1822 Bank Street

URBAN DESIGN BRIEF - R2

MARCH 17, 2025

RESPONSE TO URBAN DESIGN COMMENTS

Interior Streets

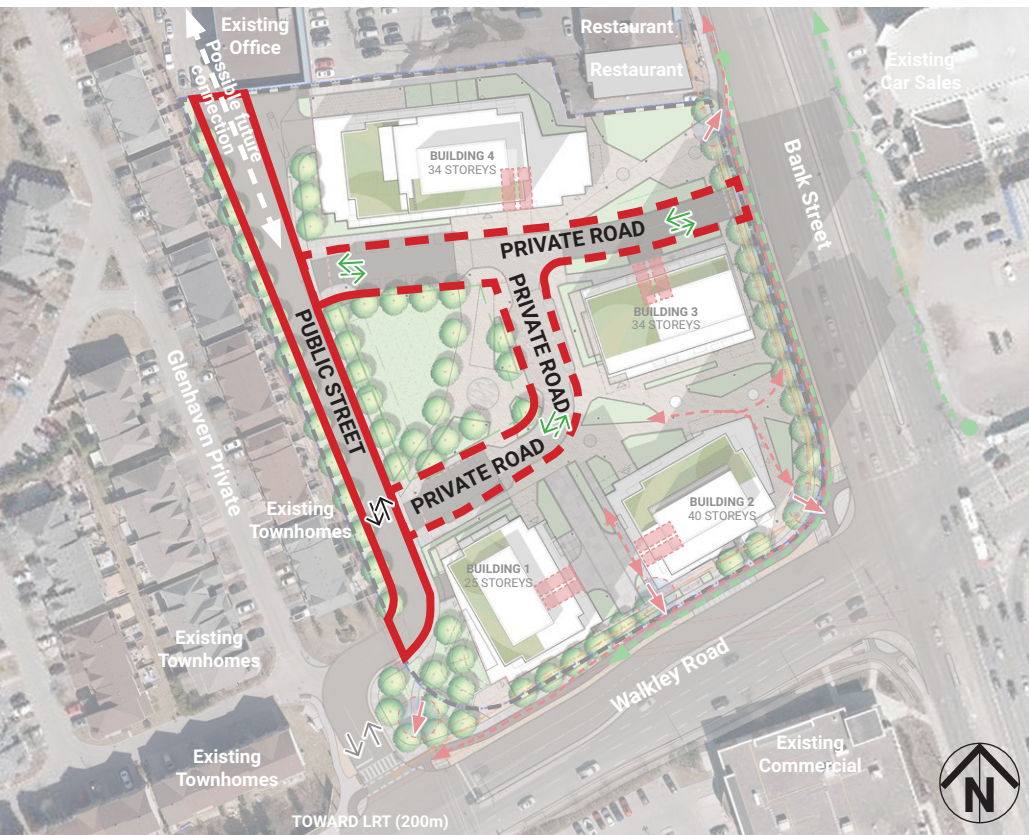
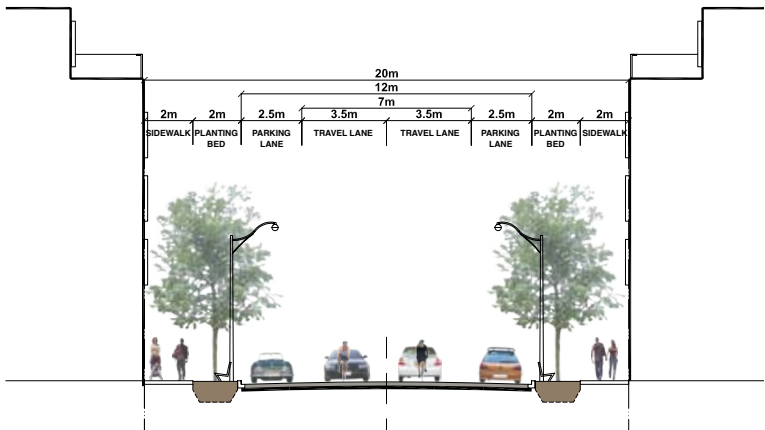
- g. The complicated, irregular, and potentially unsafe design at Walkley, Glenhaven, West Valley, and the proposed new public street intersection. The new public street makes a sharp turn within a short distance from an existing complicated intersection. The condition is further complicated by the location of the loading and parking ramp of Building 5.

Applicant: The primary issue with the Glenhaven, West Valley and new street intersection is the length of the throat to Walkley Road. Our traffic engineers are reviewing options for improvements to the design of the intersection to address existing and new traffic volumes.

VIEW FROM ABOVE NORTHWEST SHOWING 45 DEGREE ANGULAR PLANE

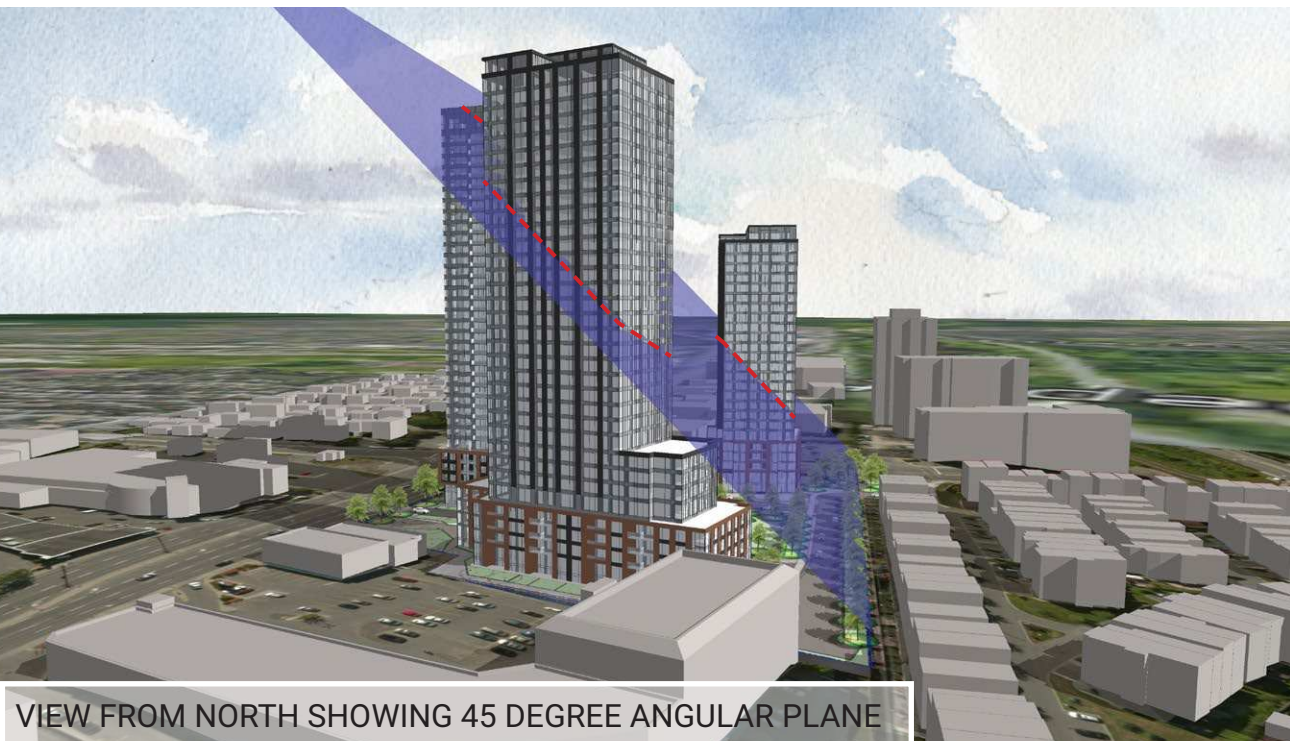
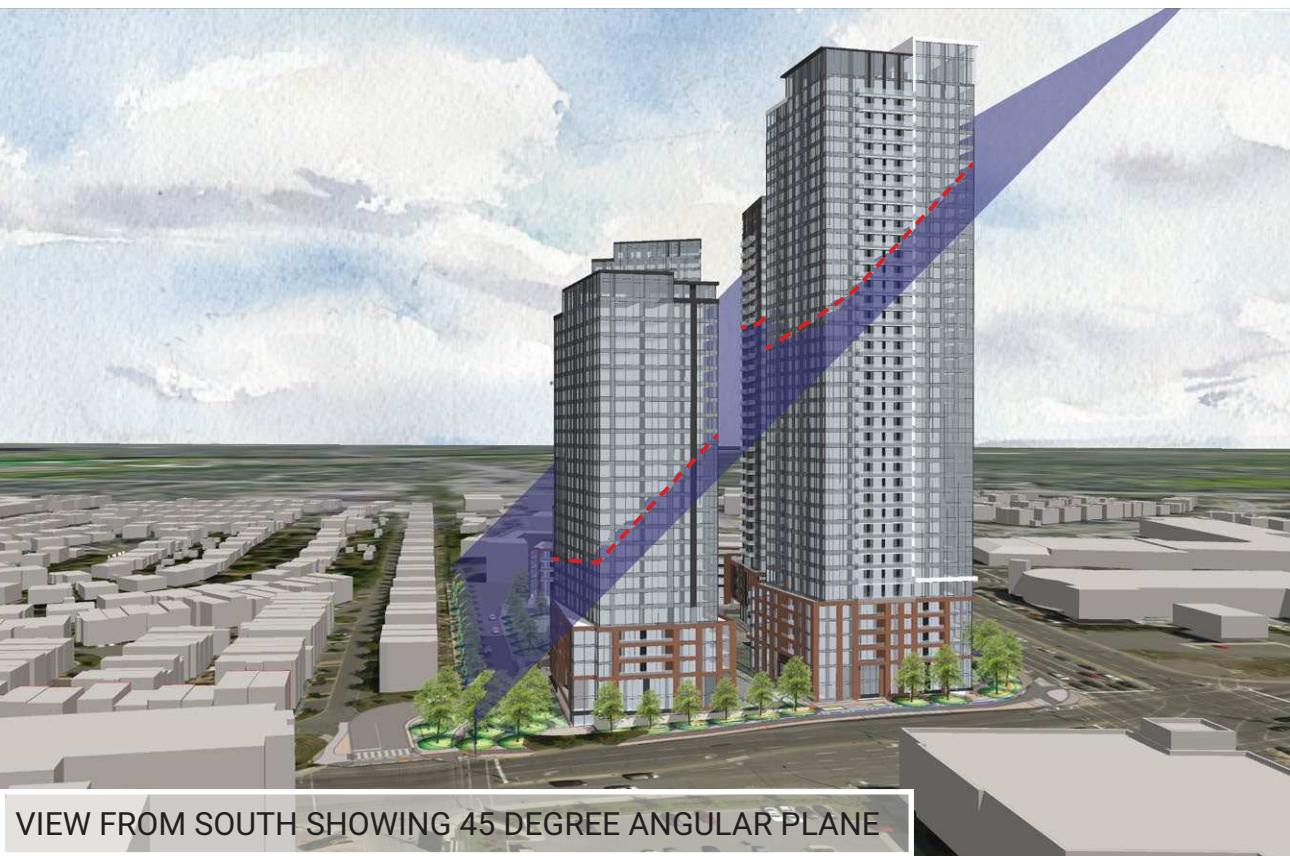
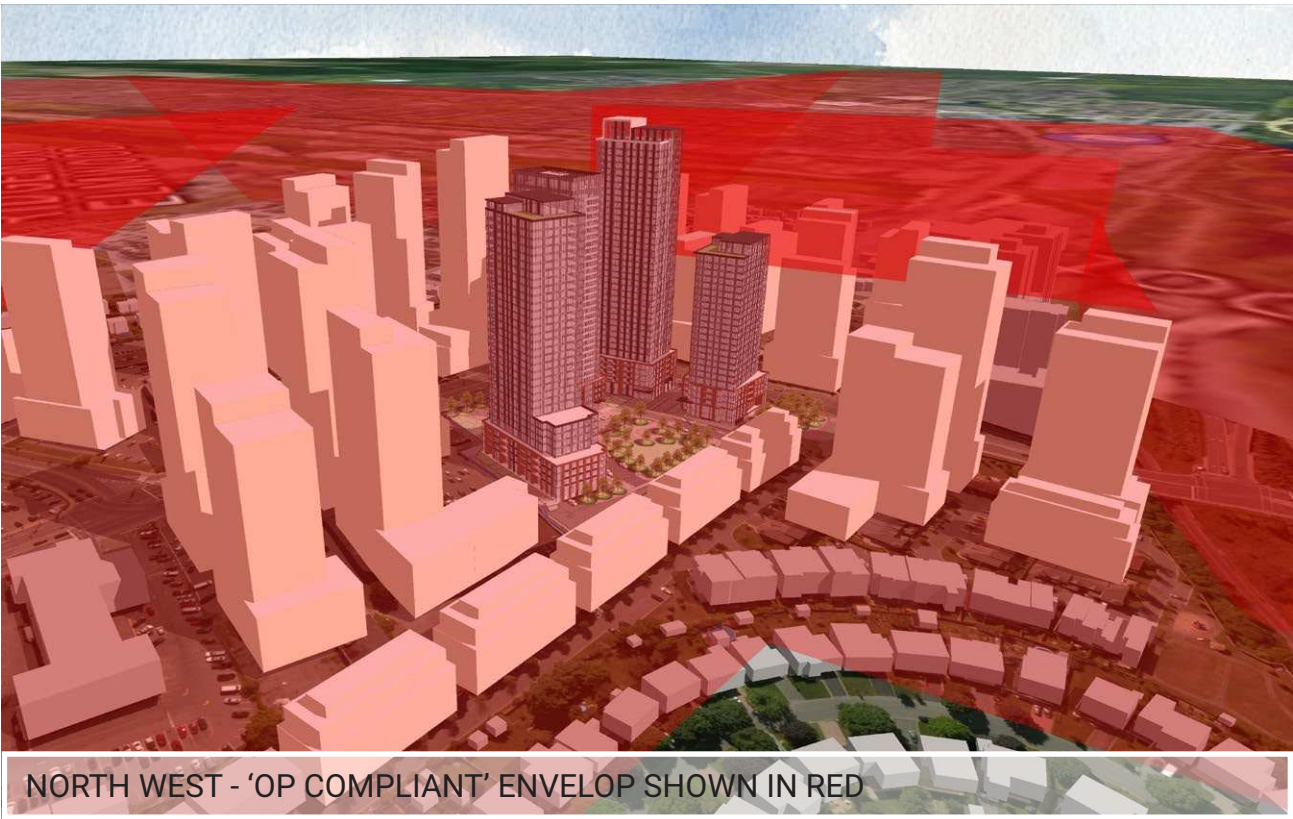
41. Ensure effective built form transition, guided by the application of angular planes.

17. Towers 1 and 4 protrude significantly above the 45-degree angular planes as shown on page 20 of the submitted Design Package.
- i. Tower 1 – At the current proposed location and floorplate size, the height of the tower appears to be too tall.
 - ii. Tower 4 – The height should be reduced. It is interesting to note that if Tower 4 is a 16-storey building, permitted by the Secondary Plan, it will not protrude above the angular plane.

28. Slide 20 of the Design Package demonstrates the buildings projecting above the angular plane. While the angular plane is not meant to be a rigid determination of heights, it does inform the general appropriateness of building heights. In this case, it seems to me that Building 4 should be reduced by several storeys. In addition to improving the building height transition, this would add more variation to the building heights.

30. In the Official Plan, Section 4.6.6, policies 1) and 3) speak to the built form transition between high-rise and low-rise to be guided by an angular plane in accordance with Council-approved Plans and Guidelines, which is further detailed in the Urban Design Guidelines for High-Rise Buildings, Section 1. In the applicant’s Design Package, slide 20, the 45-degree angular plane is applied and shows that the proposed building heights clearly and significantly exceed the angular plane. The proposed building heights for buildings 2 & 3 along Bank St are acceptable, however, buildings 1 & 4 should be reduced in height in order to provide an appropriate building height transition.

Applicant: Please refer to the angular plane diagrams included in the UDRP submission set. We feel that the proximity to the transit station and future development potential under the OP justifies some elements of the development breaking the 45 degree angular planes. The trade-off the proposed development offers is providing the majority of the western edge as greenspace. This minimizes the number of the existing townhomes impacted by overlook / shadowing.

Applicant: We acknowledge that towers 1 and 4 protude through the angular plane. However we feel that this massing response is reason given the significant adjacent open space gained by locating the park at the west side of the property closest to adjacent low-rise. The park location serves to balance the impacts of the taller building forms. Additional, building 1 is the closest of the buildings to the new transit station, and therefore an appropriate location for a taller / higher density form.
